# Wisconsin Department of Transportation

**Proposal #22: 7834-00-70**  
**T Reseburg, Broek Road**  
**Br S Fk Eau Claire River Br B100390**  
**Loc Str**  
**Clark County**

This is Addendum No. 01, which provides for the following:

**ADDENDUM NO. 01**  
**ID 7834-00-70**  
**REVISED SHEET 25**  
**AUGUST 29, 2022**

**GENERAL PLAN**

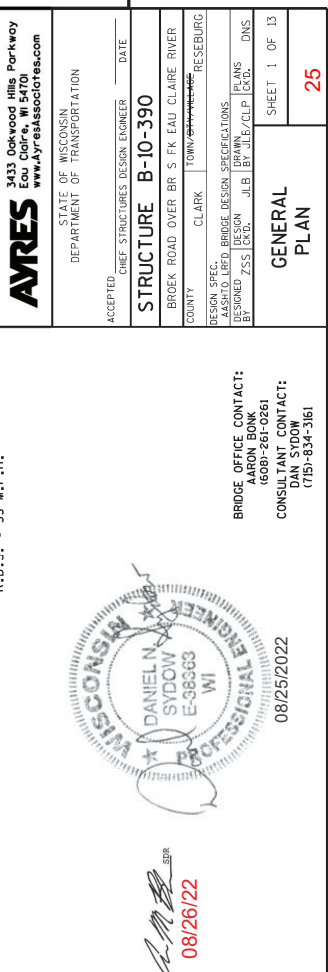
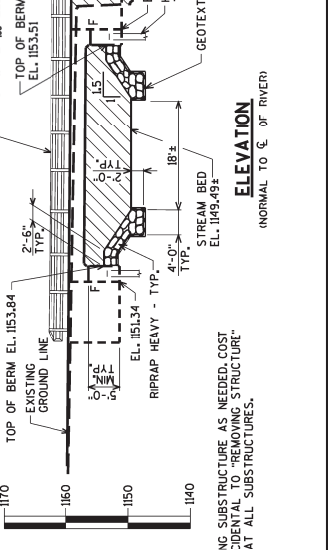
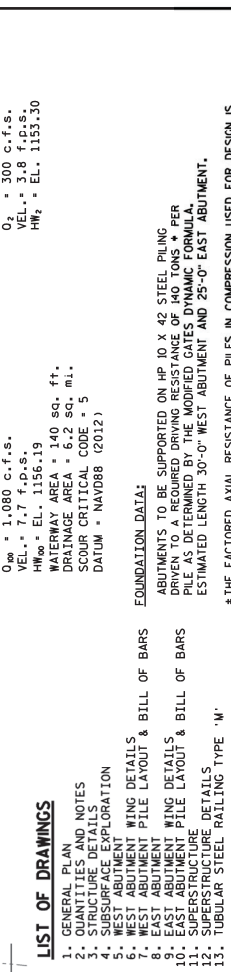
Revised Plan Sheets	
Plan Sheet	Plan Sheet Title (brief description of why sheet was added)
25	Structure Plan (removed flashing)
26	Quantities and Notes (removed flashing item)
27	Structure Details (removed flashing details)
35	Superstructure (removed flashing)

NO.	DATE	REVISION	BY
1	08/25/22	REMOVE FLASHING	DNS

**FLASHING DETAIL FOR NEW BRIDGES WITH OPEN RAILING**

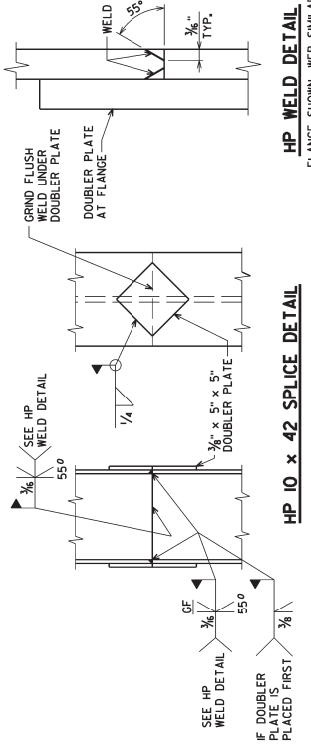
NO.	DATE	REVISION	DNS
1	08/25/22	REMOVE FLASHING	
BY			
STATE OF WISCONSIN DEPARTMENT OF TRANSPORTATION			
STRUCTURE B-10-390			
DESIGNED BY	CLIP	PLANS	ZSS
STRUCTURE DETAILS			SHEET 3 OF 13
			27

SUPERSTRUCTURE

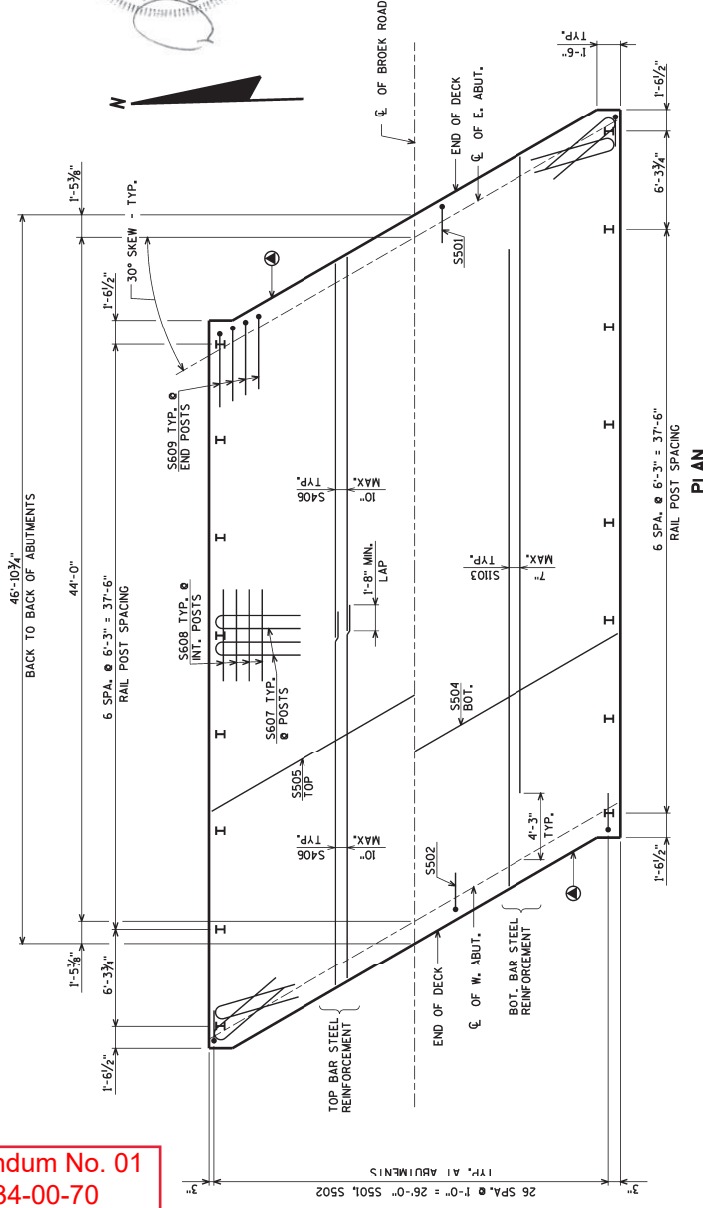
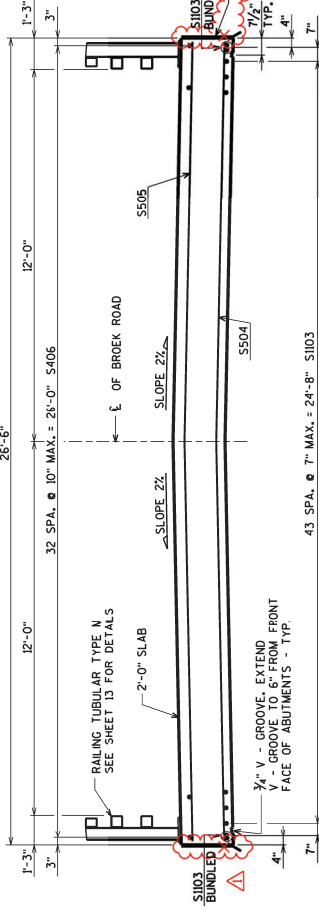
NO.	DATE	REVISION	DNS
1	08/25/22	REMOVE FLASHING
